**Re: Special Development Permit for 1390 Borregas Avenue Mechanical
Facility
File #2019-7071**

**Comments on the September 24, 2019 Letter Regarding Agenda Item No. 19-0988,
Special Development Permit for 1390 Borregas Avenue Mechanical Facility**

RE: 1390 Borregass CUP Project Air Quality Analysis - Sunnyvale, CA

Re: **Response to Comments by Adams Broadwell Joseph & Cardozo
for the Google Mechanical Facility**
1390 Borregas Avenue
Sunnyvale, California

Appendix B: Generator Information

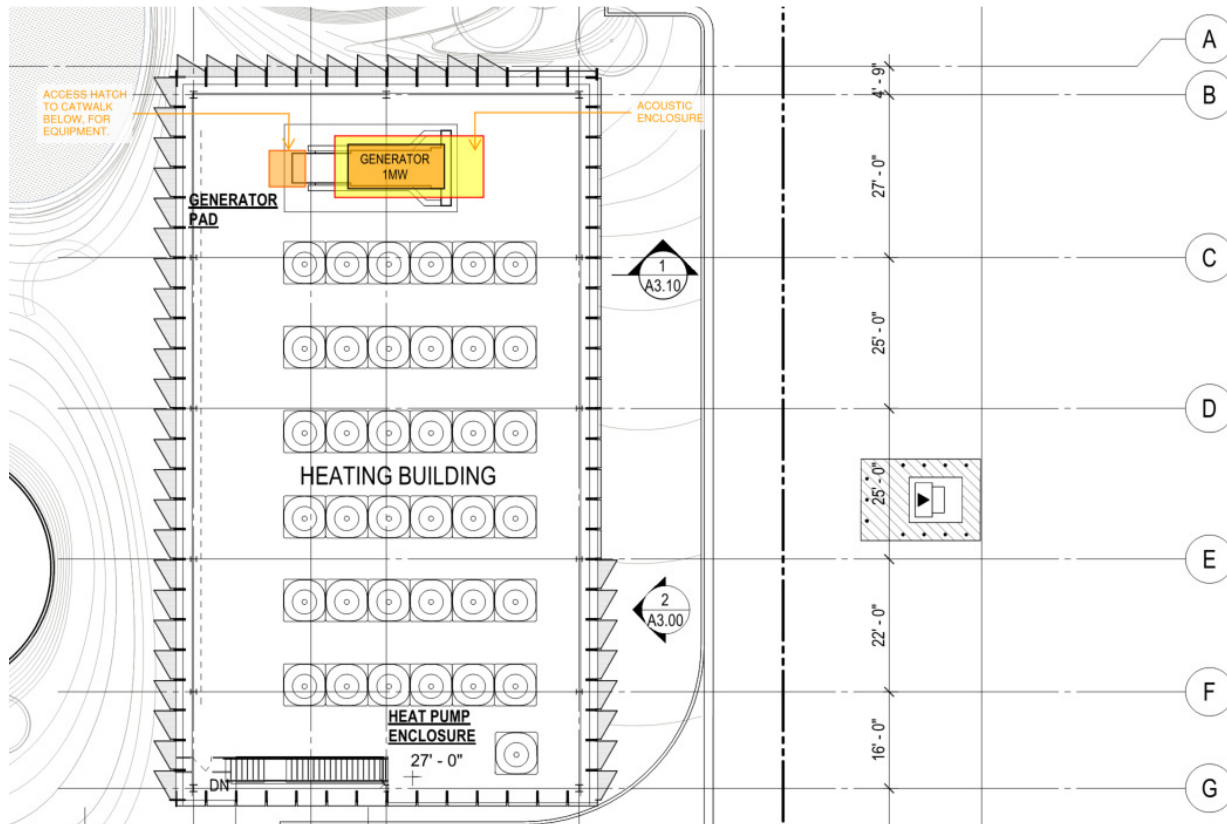
The Wilson Ihrig report states that detailed sound data for the mechanical equipment used in the noise calculations is not provided. Equipment make/model and sound data are included in Arup's mechanical drawing equipment schedules, and are not duplicated in the acoustics report. We have included relevant sound data in Appendix A of this document for clarity.

Generator with acoustic enclosure shown on Arup 100% SD Electrical Drawings (3/7/19):

Acoustic enclosure noted in Arup's 100% SD Combined Narrative (2/22/19):
